DRAWING UPDATES
02.03.26:

Project **Radcliffe Civic Hub**

Drg Title **Ecological Enhancement**

Drg No. **RADHUB-PIE-00-00-DR-L-0010** Suitability **S3** Revision **C10**

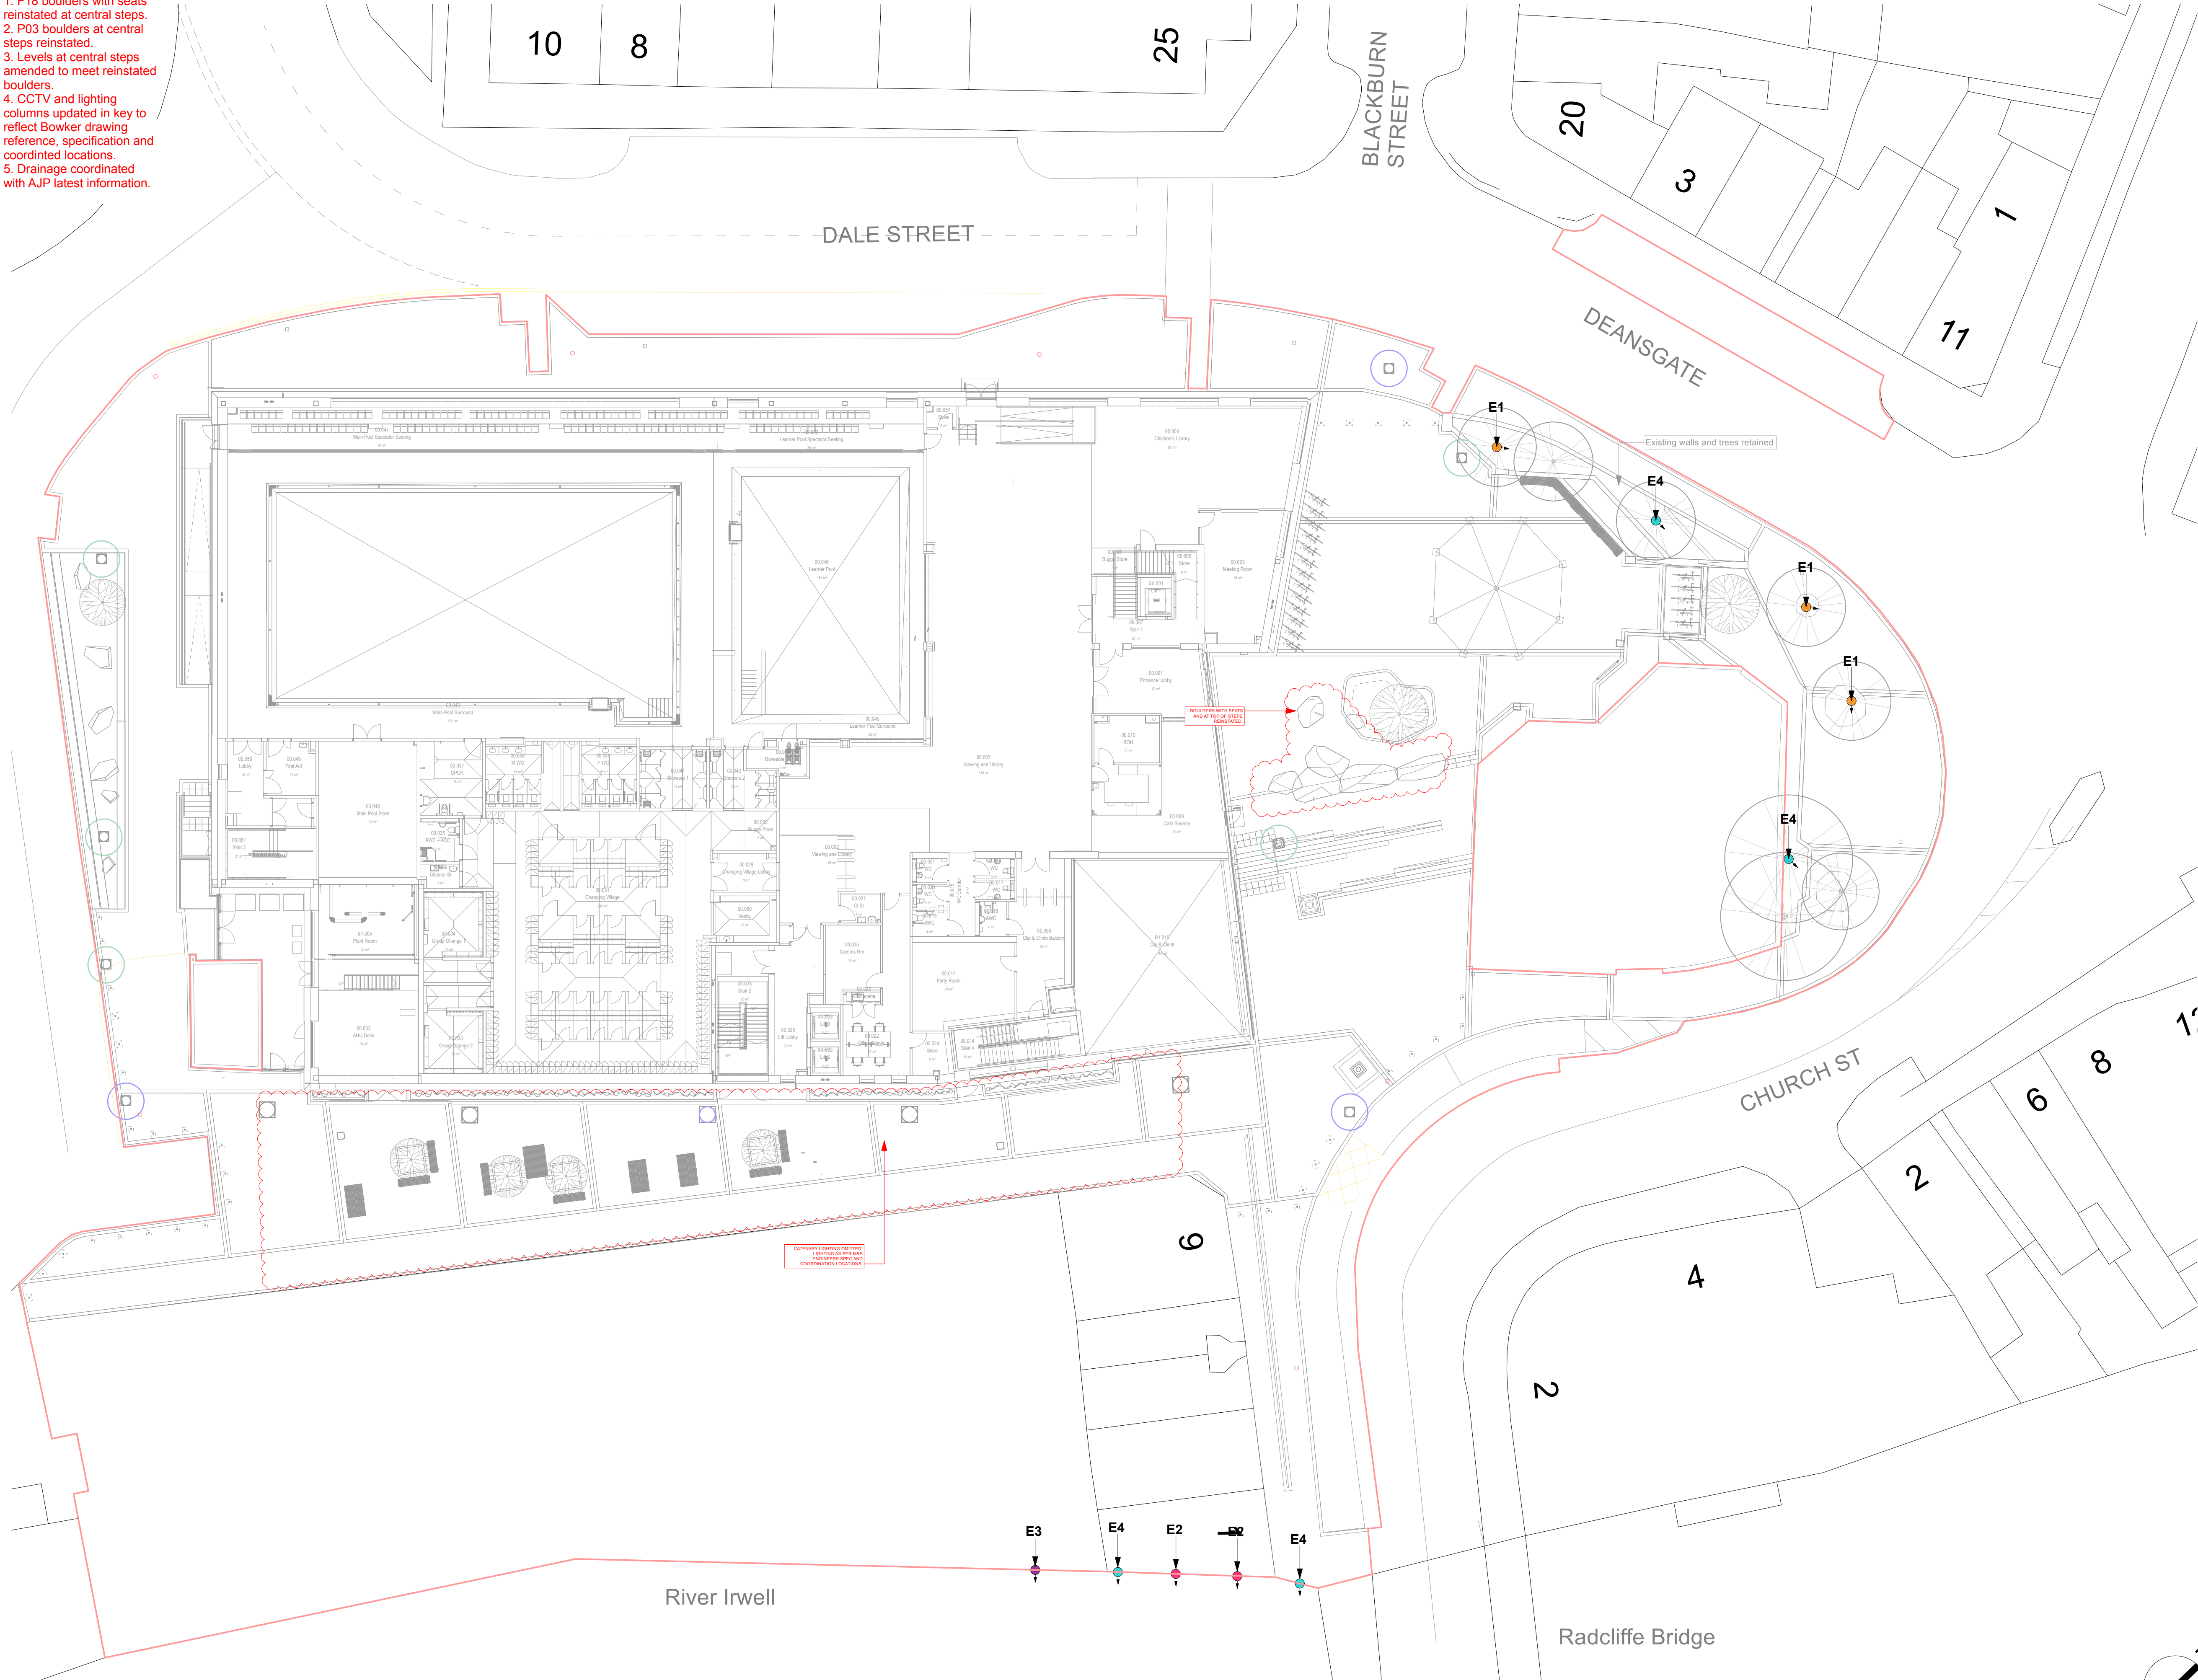
1. F18 boulders with seats reinstated at central steps.
2. P03 boulders at central steps reinstated.
3. Levels at central steps amended to meet reinstated boulders.
4. CCTV and lighting columns updated in key to reflect Bowker drawing reference, specification and coordinted locations.
5. Drainage coordinated with AJP latest information.
